Pentium® Pro Processor Specification Update

Release Date: February 1998

Order Number: 242689-025

Figure 4-3. Stack Switch on a Call to a Different Privilege Level

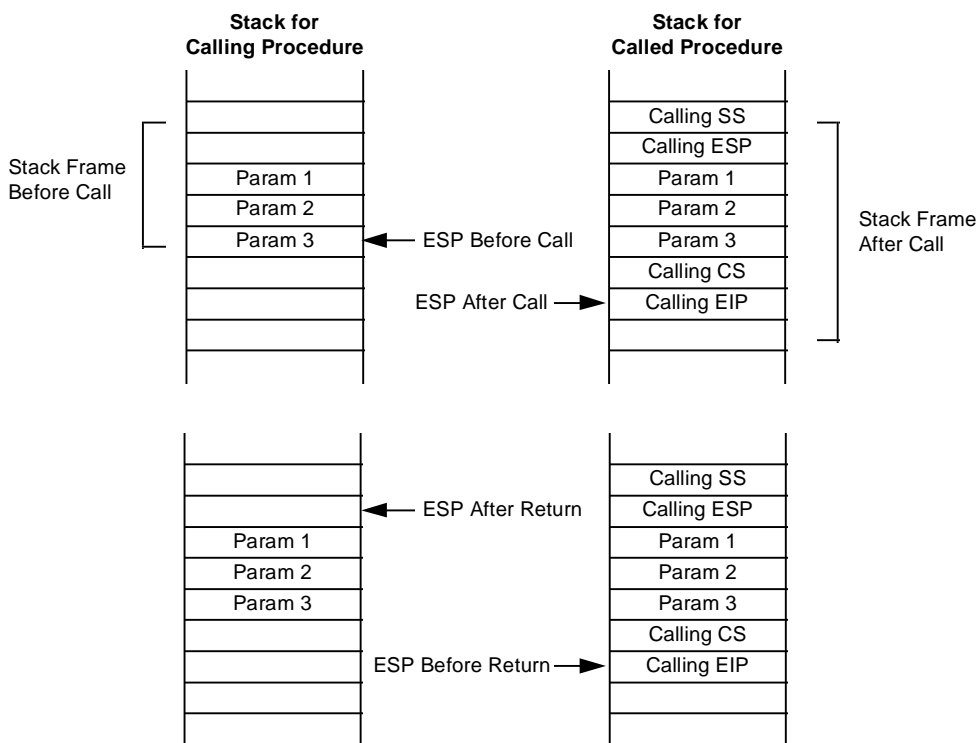
4.3.6. CALL and RET Operation Between Privilege Levels

When making a call to a more privileged protection level, the processor does the following (see Figure 4-3):

1. Performs an access rights check (privilege check).
2. Temporarily saves (internally) the current contents of the SS, ESP, CS, and EIP registers.
3. Loads the segment selector and stack pointer for the new stack (that is, the stack for the privilege level being called) from the TSS into the SS and ESP registers and switches to the new stack.

4. Pushes the temporarily saved SS and ESP values for the calling procedure's stack onto the new stack.
5. Copies the parameters from the calling procedure's stack to the new stack. (A value in the call gate descriptor determines how many parameters to copy to the new stack.)

3. (If the RET instruction has an optional *n* argument.) Increments the stack pointer by the number of bytes specified with the *n* operand to release parameters from the stack. If the call gate descriptor specifies that one or more parameters be copied from one stack to the other, a RET *n* instruction must be used to release the parameters from both stacks. Here, the *n* operand specifies the number of bytes occupied on each stack by the parameters. On a return, the processor increments ESP by *n* for each stack to step over (effectively remove) these parameters from the stacks.

4. Restores the SS and ESP registers to their values prior to the call, which causes a switch back to the stack of the calling procedure.
5. (If the RET instruction has an optional *n* argument.) Increments the stack pointer by the number of bytes specified with the *n* operand to release parameters from the stack (see explanation in step 3).

Note: On a return, parameters are released on both stacks if the correct value is given for the *n* operand in the RET *n* instruction.

Figure 4-4. Stack Usage on Transfers to Interrupt and Exception Handling Routines

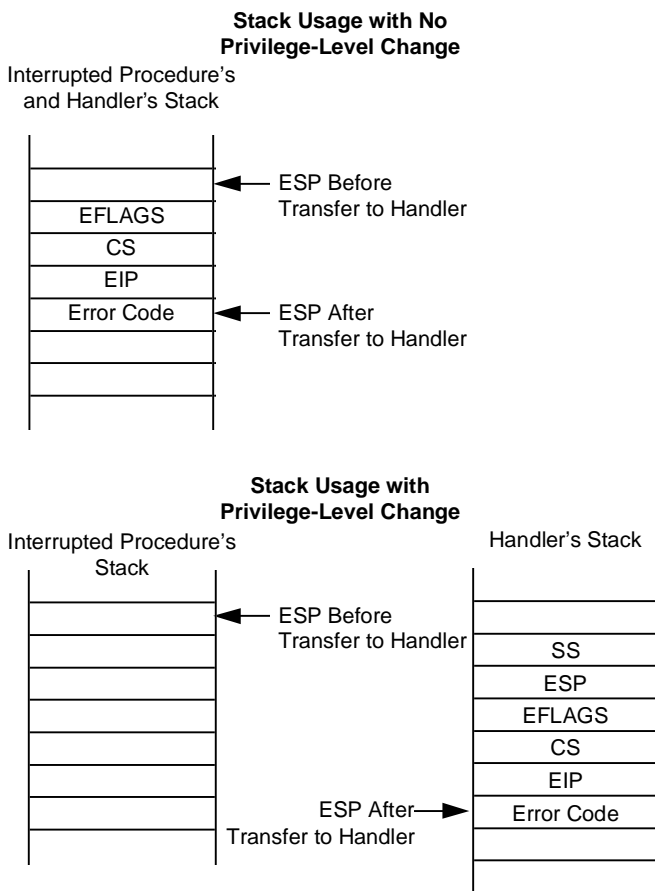
If no stack switch occurs, the processor does the following when calling an interrupt or exception handler (see Figure 44):

When executing a return from an interrupt or exception handler from a different privilege level than the interrupted procedure, the processor performs these actions:

1. Performs a privilege check.
2. Restores the CS and EIP registers to their values prior to the interrupt or exception.
3. Restores the EFLAGS register.
4. Restores the SS and ESP registers to their values prior to the interrupt or exception, resulting in a stack switch back to the stack of the interrupted procedure.
5. Resumes execution of the interrupted procedure.
